**AGENDA**  
**DESIGN REVIEW COMMITTEE**  
Lakeland City Hall, City Commission Chambers  
December 18, 2025  
immediately following the Historic Preservation Board Meeting

**HISTORIC PRESERVATION BOARD  
DESIGN REVIEW COMMITTEE  
STAFF REPORT  
December 18, 2025**

<b>Project #</b>	<b>HPB25-195</b>
<b>Project Type</b>	<b>Minor Exterior Alteration</b>
<b>Property Address; Historic Name</b>	<b>1926 Cherokee Trail / Fussell-Trohn House</b>
<b>Historic District; FMSF#</b>	<b>Beacon Hill; #PO02646</b>
<b>Owner/Applicant</b>	<b>Jeffrey and Megan Lazenby / ValuePro Remodeling &amp; Maintenance</b>
<b>Zoning; Future Land Use; Context District; SPI</b>	<b>Residential Medium; RA-1; Urban Neighborhood; None</b>
<b>Existing Use</b>	<b>Residential</b>
<b>Adjacent Properties</b>	<b>Residential</b>
<b>Previous Approvals</b>	<b>Window Replacement, 4/26/2018 (HPB18-066); Pool, 3/16/2022 (HPB22-059)</b>

<b>Project #</b>	<b>HPB25-218</b>
<b>Address; Historic Name</b>	<b>1056 South Boulevard; William and Myrtle Carpenter House (1924 CD)</b>
<b>Owner/Applicant</b>	<b>Alexa Lashkajani / Alan DeZayas, Avon Modular LLC</b>
<b>Project Type</b>	<b>Building Addition, Replacement Windows,</b>
<b>Historic Di

EXTERIOR ELEVATION - NORTH SIDE  
SCALE: 3/8" = 1'-0"

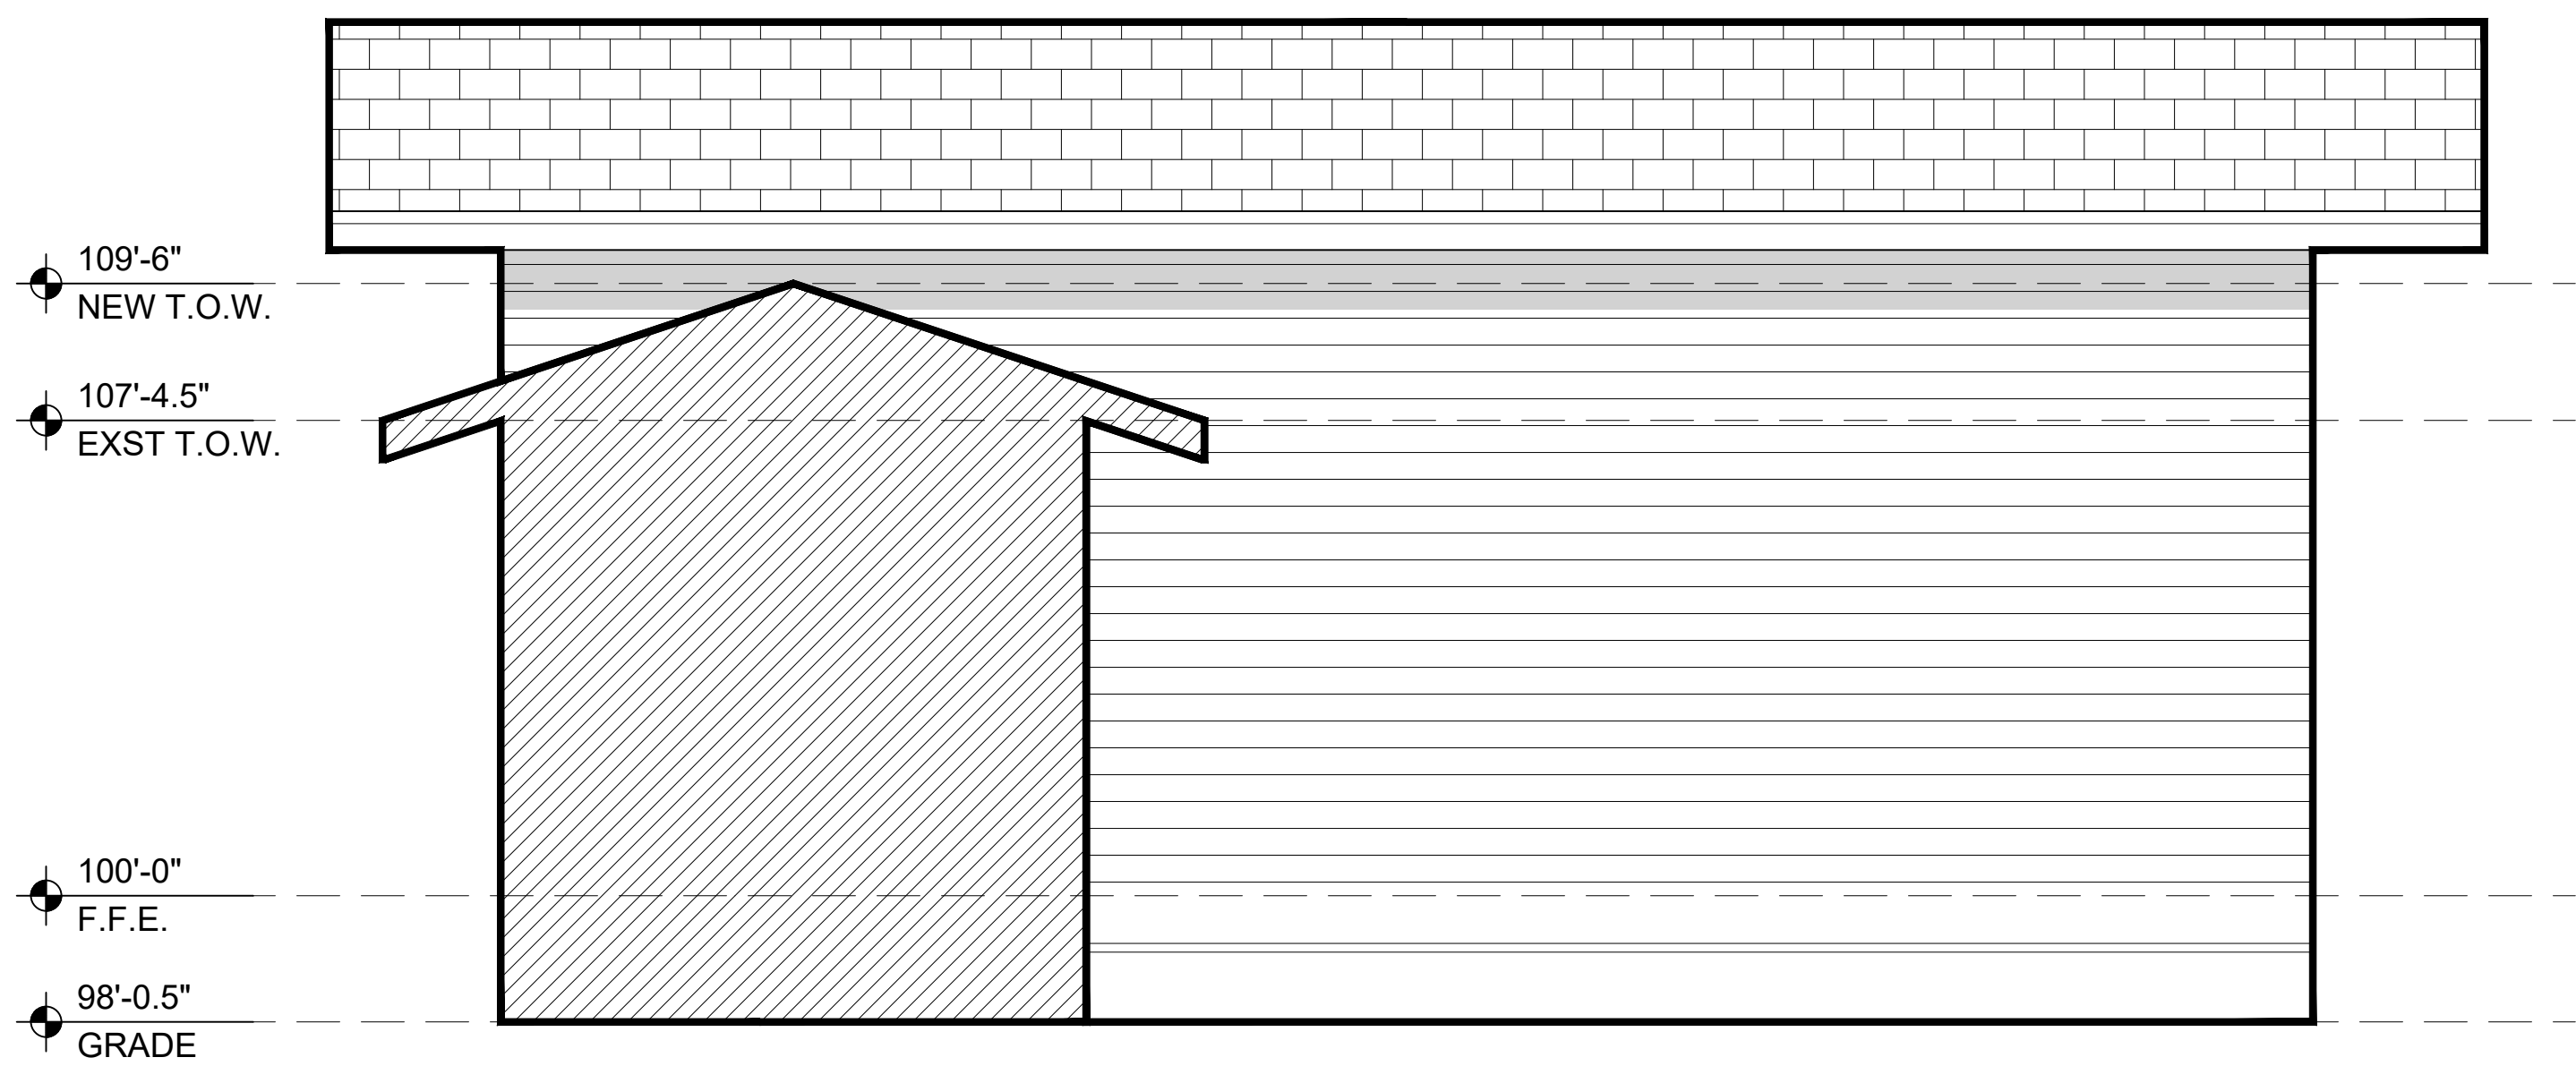
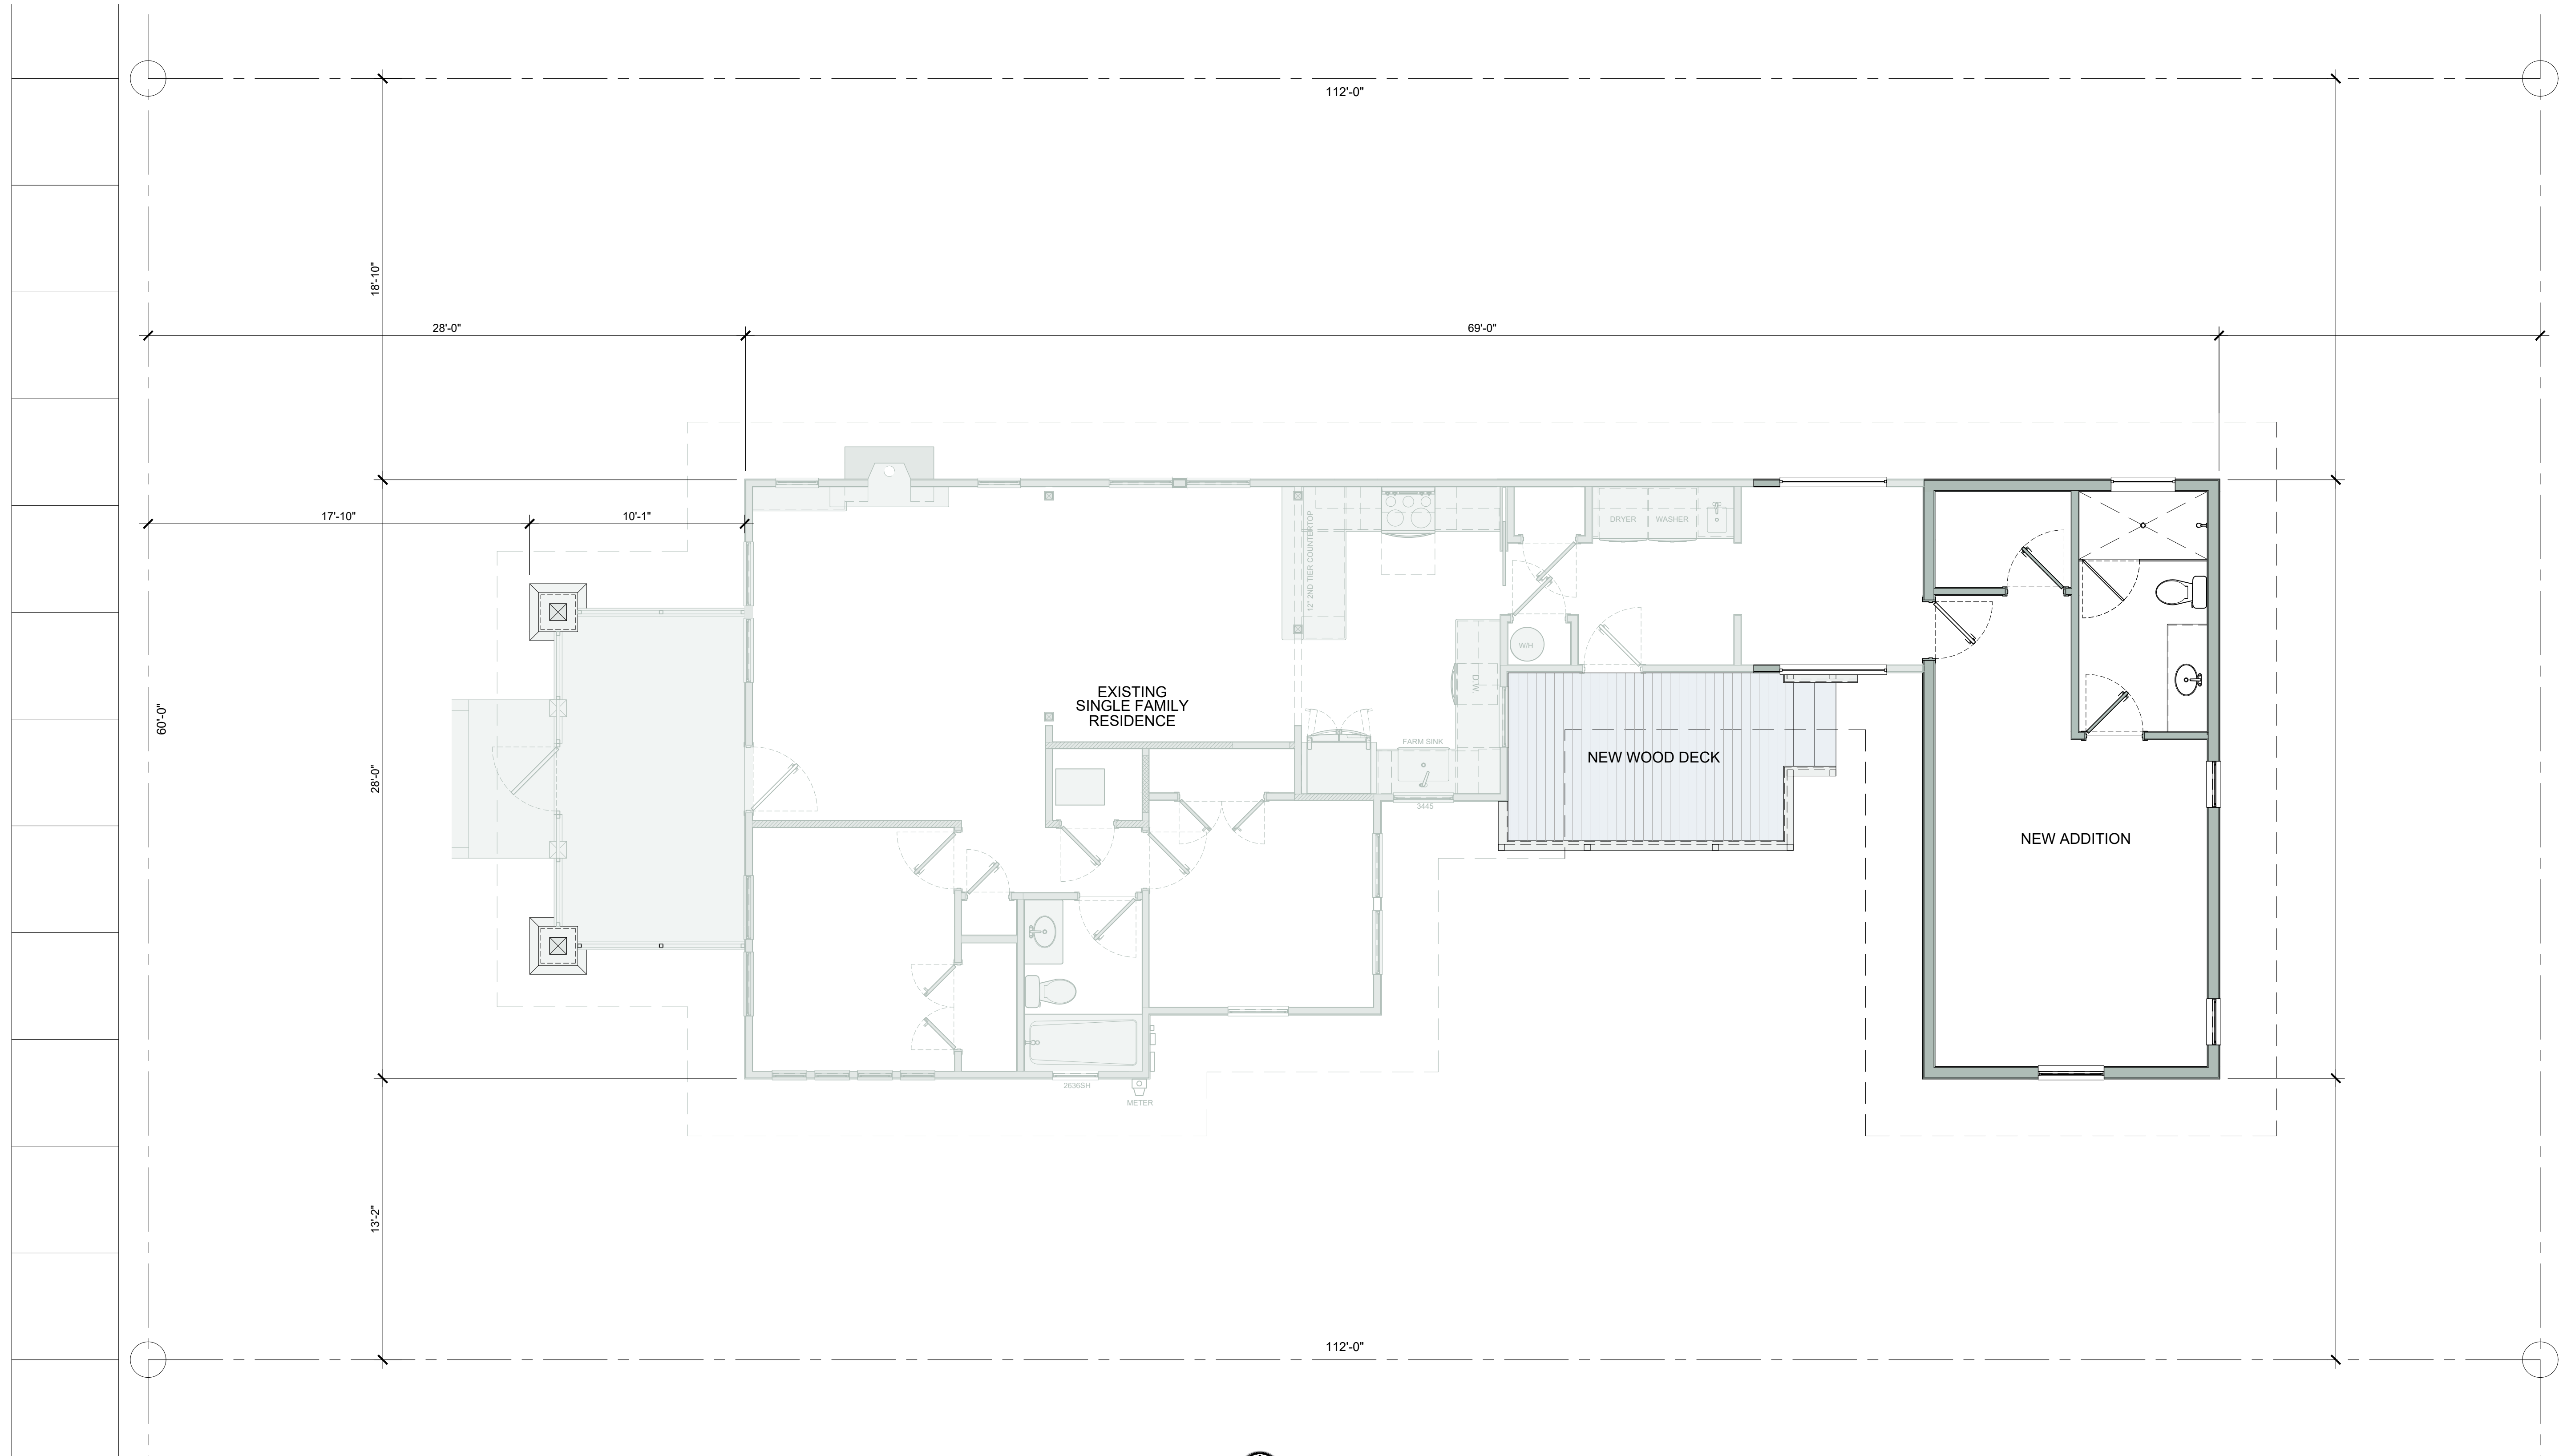
Regarding the request for the addition, staff finds the requested addition is consistent with the Standards as it does not disturb the spatial relationships that characterize the house, and the essential form and integrity of the subject house is maintained. The new addition is differentiated from the house by its subordinate massing and perpendicular orientation, which is similar to the orientation of the detached garage to be demolished. However, for further differentiation from the house, staff recommends not using a simulated divided lite appearance on the building addition's windows, especially as the addition is located at the rear of the property and will not be highly visible from the street. Additionally, the proposed simulated divided lite configuration of the windows on the addition are not consistent with the divided lite configuration of the home's historic windows.

In evaluating the proposed addition with the Design Guidelines, the materials of the and addition reflect the materials of the existing house and meet the intent of the Design Guidelines. The scale of proposed

addition's windows, wall cladding, and roof pitch and form is consistent with the Craftsman Bungalow style of the subject house. Furthermore, the addition is appropriately placed on the rear elevation of the house.

Regarding the request for replacement windows, typically, this type of request can receive approval under Minor Review (staff-level review) if the request is justified and complies with the Standards and Design Guidelines. Historic windows are character-defining features of a historic building, and the removal of repairable historic windows and installation of inappropriate replacement windows can adversely affect the architectural integrity of a building. As the request is not consistent with the Standards and Design Guidelines, and staff was not provided adequate evidence to show that the historic windows are deteriorated beyond reasonable repair, this request could not be approved at the Minor Review level. Additionally, the proposed replacement windows do not match the divided lite appearance of the historic double-hung sash (9-over-1 and 9-over-9 lite configuration) and casement (9-lite configuration) windows. For these reasons, staff recommends that the historic wood windows be repaired by a qualified window restoration professional instead of being replaced as requested.

1. Final Approval of the requested addition with the following conditions, to be reviewed and approved by staff prior to the issuance of a building permit:
  - a. Windows shall be recessed to provide a shadow line.
  - b. Windows shall not have a simulated divided lite appearance.
2. Denial of the request to replace the historic wood windows.
